09/610,510 07/06/00 ROTH

Office Action Summary

This is the first office action for application number 09/610,510, Apparatus For Stiffening A Hanger Rod, filed on July 6, 2000.

3,318,561

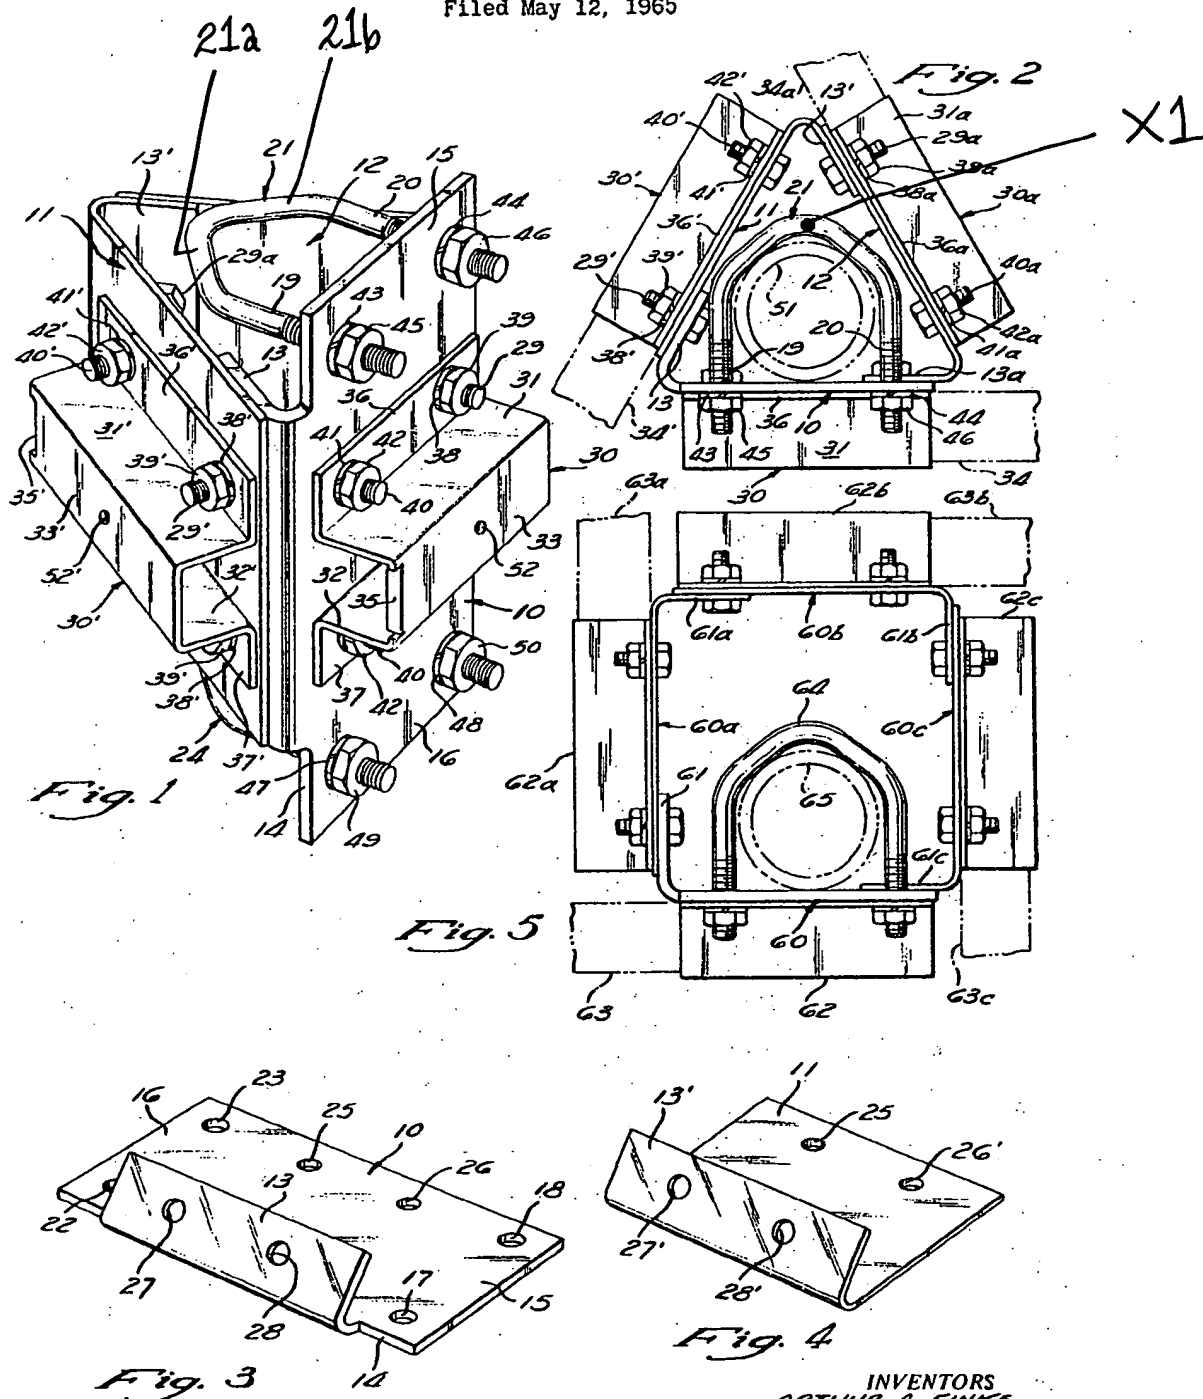
Claims 1-2, 4, 7 and 9 are rejected under 35 U.S.C. 102(b) as being anticipated by U.S. Patent 3,318,561 to Finke et al. Finke et al. discloses a stiffener apparatus (note attached marked-up copy of Figs. 1-2) including a clamp 21, a plate 10, nuts 46 and an elongated stiffener member 51. Finke et al. discloses that the clamp has two straight, double-ended, spaced, parallel first clamp segment 19 and second clamp segment 20, and a third clamp segment 21a,21b integral with and extending between an end of the first clamp segment and an end of the second clamp segment. In addition, Finke et al. discloses that the plate 10 (note Fig. 3) defines spaced openings 17,18 where the ends of the first and second clamp segments which are remote from the third clamp segment project through the openings (note Figs. 1-2).

Finke et al. also discloses that nuts threadedly engage with the ends of the first and second clamp segments which project through the openings (note Figs. 1-2). Furthermore, Finke et al. discloses that the elongated stiffener member is disposed between the plate and the third clamp segment (note Fig. 2) wherein at least a portion 21a,21b of the third clamp segment is straight and non-orthogonally disposed relative to

Finke et al. also discloses that the third clamp segment includes an interconnected first straight portion 21a and second straight portion 21b extending at obtuse angles with respect to the first and second clamp portions (note Fig. 2). Additionally, Finke et al. discloses that the first and second portions connect at a location X1 substantially midway between the first and second clamp segments. Finally, Finke et al. discloses that the stiffener member has a circular-shaped outer peripheral bearing surface (note Fig. 2).
